Intel Action Alert

AA-0842-1

Electromagnetic Conformance change required for Intel® Remote Management Module NIC

Intel® Remote Management Module
Product Code AXXRMM

Figure 1 – PCI bracket, EMI gasket and NIC

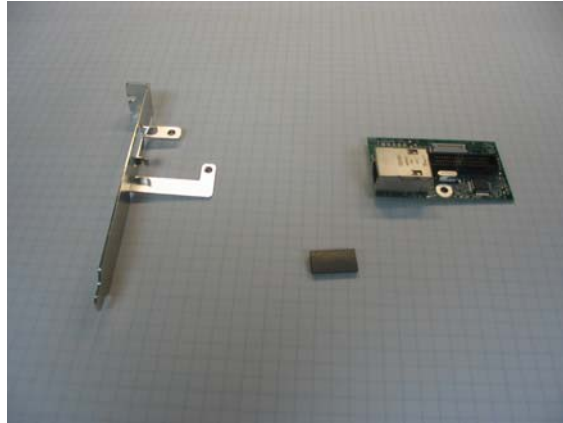
This section provides the steps to correctly install the Intel RMM NIC module into pedestal chassis configurations to reduce EMI emissions. Figure 1 shows the PCI bracket, EMI gasket, and Intel RMM NIC module that will be used for this installation.

Figure 2 – Cutting the EMI gasket

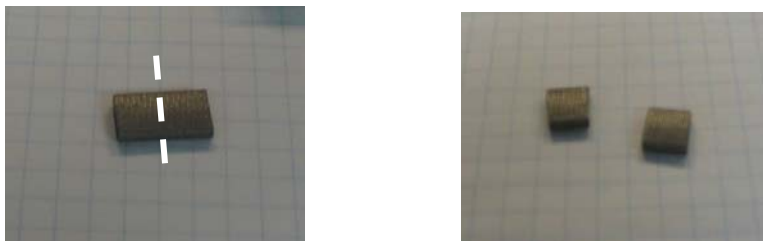
2-   Cut the EMI gasket in half across the short side. See Figure 2.

Figure 3 – Properly placing the EMI gasket

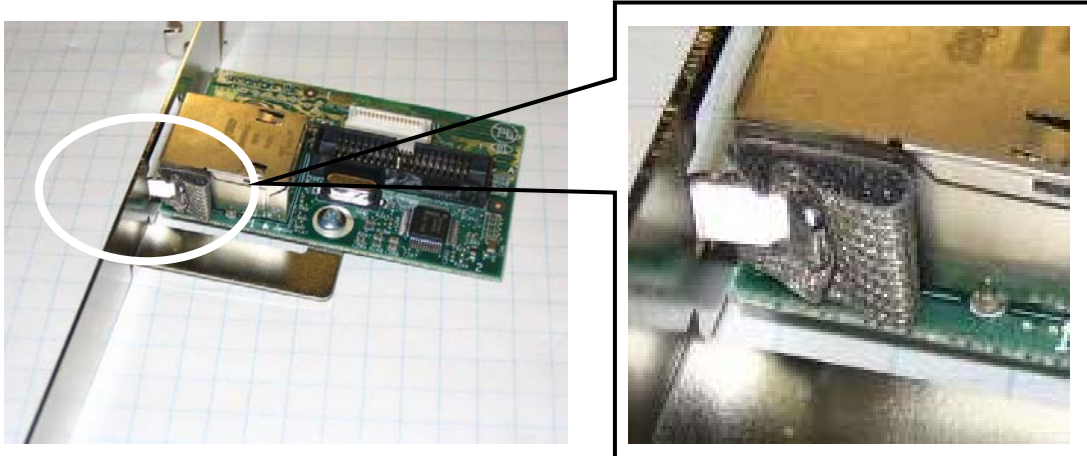
3-   Place the EMI gasket between the ear of the PCI bracket and the RJ-45 connector on the NIC module. Fasten the NIC module to the bracket using the screws provided. See Figure 3.

IMPORTANT NOTE: Place the EMI gasket only as shown in Figure 3. DO NOT place the EMI gasket on the side of the RJ-45 near exposed components. Damage may occur if the EMI gasket is placed near exposed components.

Figure 5 – Attaching EMI gasket to RJ-45

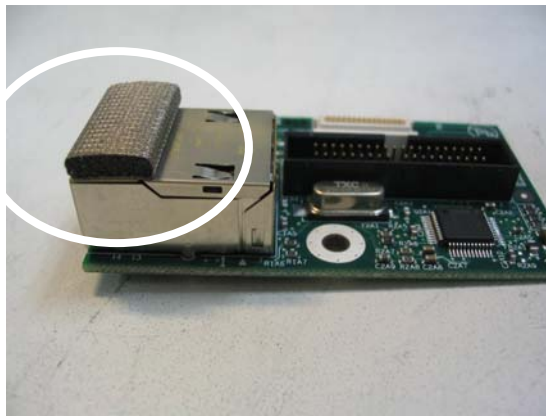
2-   Using the adhesive strip on the EMI gasket, attach it to the RJ-45 connector on the NIC module. See Figure 5.

Figure 6 – Standoff position and filler removal

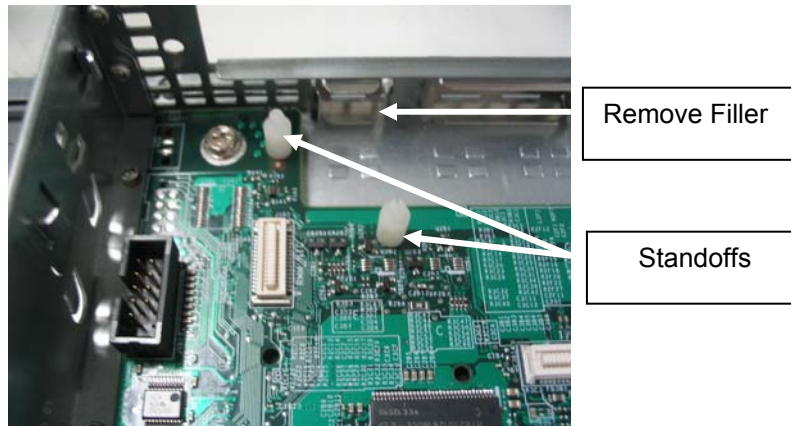
3-   Install two plastic standoffs into the server board and remove the filler plate from the chassis opening. See Figure 6.

Figure 7 – NIC module mounted to server board using standoffs

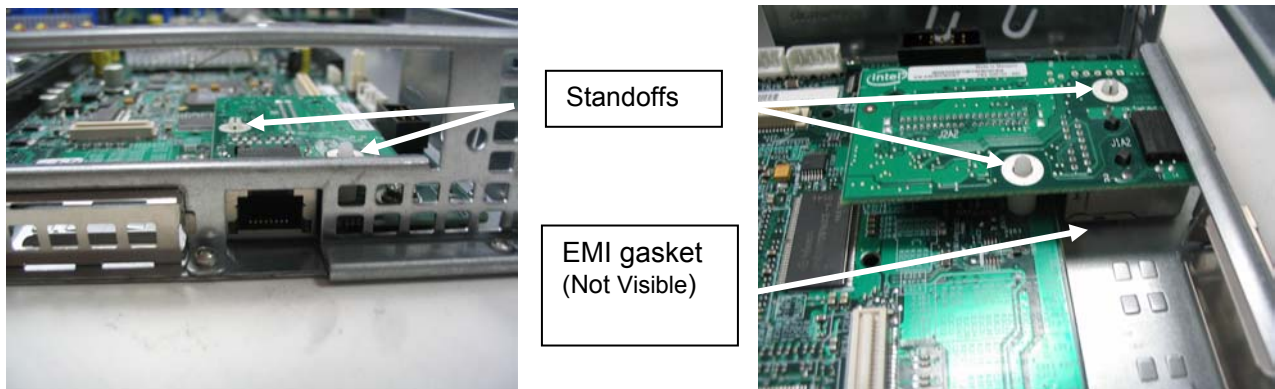
4-   Mount the NIC module onto the standoffs as shown in Figure 7. In this chassis configuration the EMI gasket will be between the RJ-45 connector and the chassis base. Complete the Intel® RMM installation following the instructions in the Quick Start Users Guide. http://support.intel.com/support/motherboards/server/s5000pal/sb/CS-022662.htm. You will see several versions of the Quick Start Users Guide. They are all identical for installing the Intel® RMM. View the back side of any of the guides.
